# UNITED STATES PATENT AND TRADEMARK OFFICE

APPLICATION NO.	FILING DATE	FIRST NAMED INVENTOR	ATTORNEY DOCKET NO.	CONFIRMATION NO.
10/646,478	08/22/2003	Daisuke Kawagoe	884.937USI	9311
21186	7590	03/21/2006	EXAMINER	
SCHWEGMAN, LUNDBERG, WOESSNER & KLUTH 1600 TCF TOWER 121 SOUTH EIGHT STREET MINNEAPOLIS, MN 55402			PATEL, ISHWARBHAI B	
			ART UNIT	PAPER NUMBER
			2841

## Office Action Summary

## DETAILED ACTION

FIG. 6

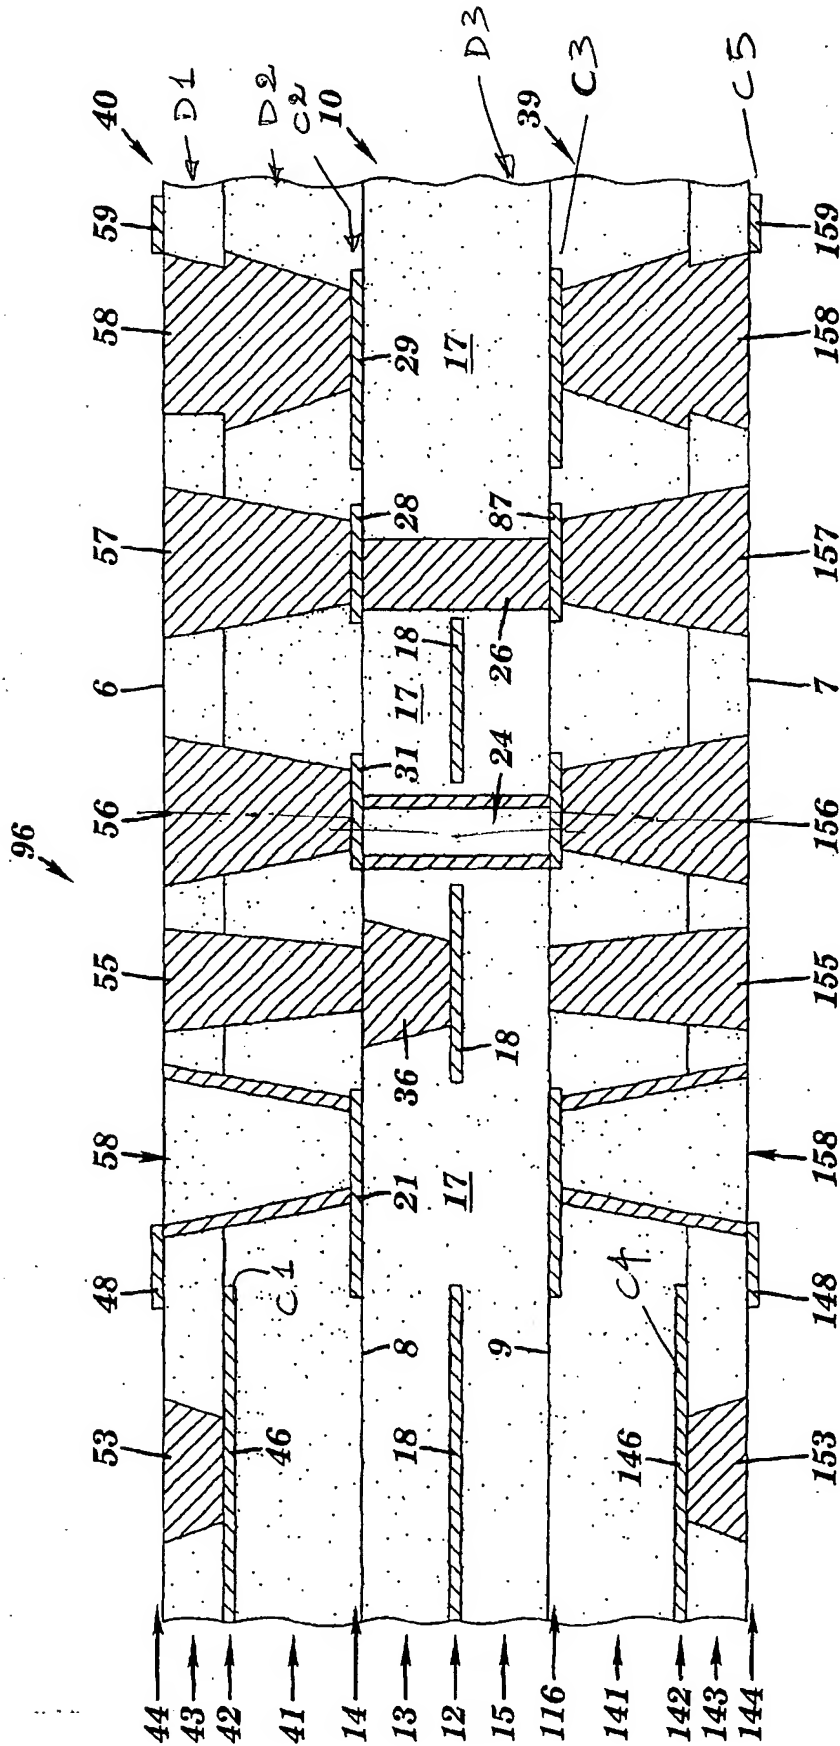
**Regarding claim 40**, Carpenter, in figure 6, discloses a substrate comprising: a first dielectric layer (D1, as marked up on figure 6 in appendix "A"); a second dielectric layer (D2, as marked up on figure 6 in appendix "A"); a first conductive layer (C1, as marked up on figure 6 in appendix "A"); between the first and second dielectric layers; a third dielectric layer (D3, as marked up on figure 6 in appendix "A"); the second dielectric layer being between the first and third dielectric layers; a second conductive layer (C2, as marked up on figure 6 in appendix "A"); between the second dielectric layer and the third dielectric layer, the second conductive layer including a first skip via (57) that extends through the first and second dielectric layers; and a third conductive layer (C3) on the third dielectric layer, the third conductive layer including a second via (26) that extends through the third dielectric layer, the second via and the first skip via being stacked on top of one another (see marked up figure 6 in appendix "A").

**Regarding claim 41**, Carpenter further discloses the first skip via includes a longitudinal axis (longitudinal axis passing through the first skip via, see marked up in figure 6, in appendix "A") and the second via includes a longitudinal axis (longitudinal axis passing through the second via, see marked up in figure 6, in appendix "A"), the longitudinal axis of the first skip via being substantially aligned with the longitudinal axis of the second via (see marked up in figure 6, in appendix "A").

**Regarding claim 42**, Carpenter further discloses the first, second and third dielectric layers are formed on a core (C5, see marked up in figure 6, in appendix "A").

**Regarding claim 43**, Carpenter further discloses a fourth conductive layer (C4, see marked up in figure 6, in appendix "A") between the first dielectric layer and the core.

The applicant argues that layer C2 (second conductive layer) does not include any vias. Therefore, Carpenter does not teach or suggest "the second conductive layer including a first skip via that extends through the first and second dielectric layers". This is not found to be correct. Via (57) as shown in marked up figure 6 (appendix "A"), does extend through dielectric layer D1 and D2 and is connected with the conductive layer (C2).

Applicant further argues that layer C3 (third conductive layer in marked up figure 6 (appendix "A")) does not include any via. Therefore, carpenter does not teach or suggest "the third conductive layer including a second via that extends through the third dielectric layer". This is not found to correct. Via (26) as shown in marked up figure 6 (appendix "A"), does extend through the dielectric layer D3 and is connected with the conductive layer (C3).

FIG. 7

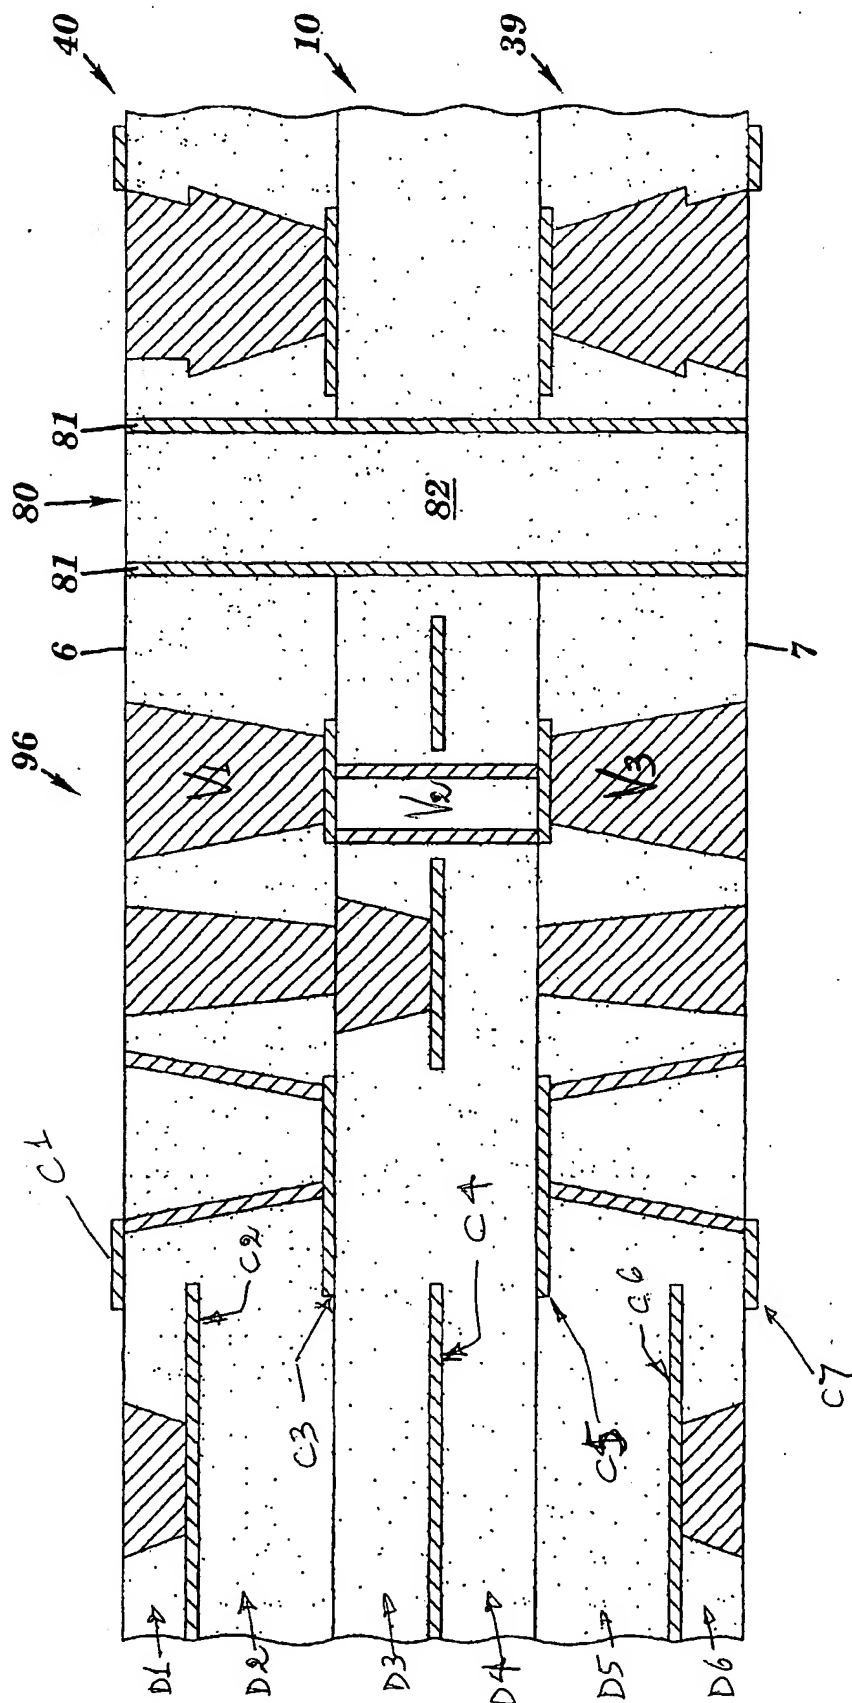
**Regarding claim 47**, Carpenter, in figure 7, discloses a substrate comprising: a first dielectric layer (D1, marked up on figure 7 in appendix "B"); a second dielectric layer (D2, marked up on figure 7 in appendix "B"); a first conductive layer (C2, marked up on figure 7 in appendix "B") between the first and second dielectric layers; a third dielectric layer (D3, marked up on figure 7 in appendix "B"), the second dielectric layer being between the first and third dielectric layers; a second conductive layer (C3, marked up on figure 7 in appendix "B") between the second and third dielectric layers, the second conductive layer including a first skip via (V1, marked up on figure 7 in appendix "B") that extends through the first and second dielectric layers; a fourth dielectric layer (D4, marked up on figure 7 in appendix "B"), the third dielectric layer being between the second and fourth dielectric layers; a third conductive layer (C4, marked up on figure 7 in appendix "B") between the third and fourth dielectric layers; and a fourth conductive layer (C5, marked up on figure 7 in appendix "B") on the fourth dielectric layer, the fourth conductive layer including a second skip via (V2, marked up on figure 7 in appendix "B") that extends through the third and fourth dielectric layers, the second skip via and the first skip via being stacked on top of one another (see marked figure 7 in appendix "B").

**Regarding claim 48**, Carpenter further discloses the first skip via and the second skip via each include a longitudinal axis (longitudinal axis of axis of first skip via and second skip via), the longitudinal axis of the first skip via being substantially aligned

with the longitudinal axis of the second skip via (see marked up figure 7 in appendix "B").

**Regarding claim 49**, Carpenter further discloses the first, second, third and fourth dielectric layers are formed on a core (C7, as marked up on figure 7 in appendix "B").

**Regarding claim 50**, Carpenter further discloses a fifth conductive layer (C6, marked up on figure 7 in appendix "B") between the first dielectric layer and the core.

**Regarding claim 54**, Carpenter discloses all the features of the claimed invention as applied to claim 47 above, including a fifth dielectric layer (D5, marked up on figure 7 in appendix "B"), the fourth conductive layer (C5, marked on figure 7 in appendix "B") being between the fourth and fifth dielectric layers; a sixth dielectric layer (D6, marked up on figure 7 in appendix "B"), the fifth dielectric layer being between the fourth and sixth dielectric layers; a fifth conductive layer (C6, marked up on figure 7 in appendix "B") between the fifth and sixth dielectric layers; a sixth conductive layer (C7, marked up on figure 7 in appendix "B") on the sixth dielectric layer. Carpenter further discloses a third sip via (V3, marked up on figure 7 in appendix "B"), a third skip via that extends through the fifth and sixth dielectric layers, but does not disclose the sixth conductive layer including connected to the third skip via. However, as can be seen at various places in the figure, the conductor layer / patterns are connected to the via depending upon the desired electrical connection for signal, power or ground connections.

substantially aligned with the longitudinal axis of the second and third skip vias (see marked up figure 7 in appendix "B").

**Regarding claim 56**, Carpenter further discloses the first, second, third, fourth, fifth and sixth conductive layers are patterned conductive layers (see figure marked up figure 7 in appendix "B").

Similarly regarding the independent claim 47, the applicant argues that Carpenter does not disclose or teach the second conductive layer including a first skip via that extends through the first and second dielectric layers and the fourth conductive layer including a second skip via that extends through the third and fourth dielectric layers. This is not found to be correct. Via (V1, as shown in figure 7, appendix B) extend through dielectric layers D1 and D2 and is connected to conductive layer C3. Similarly Via (V2) extend through dielectric layer D3 and D4 and connected to conductive layer C5.
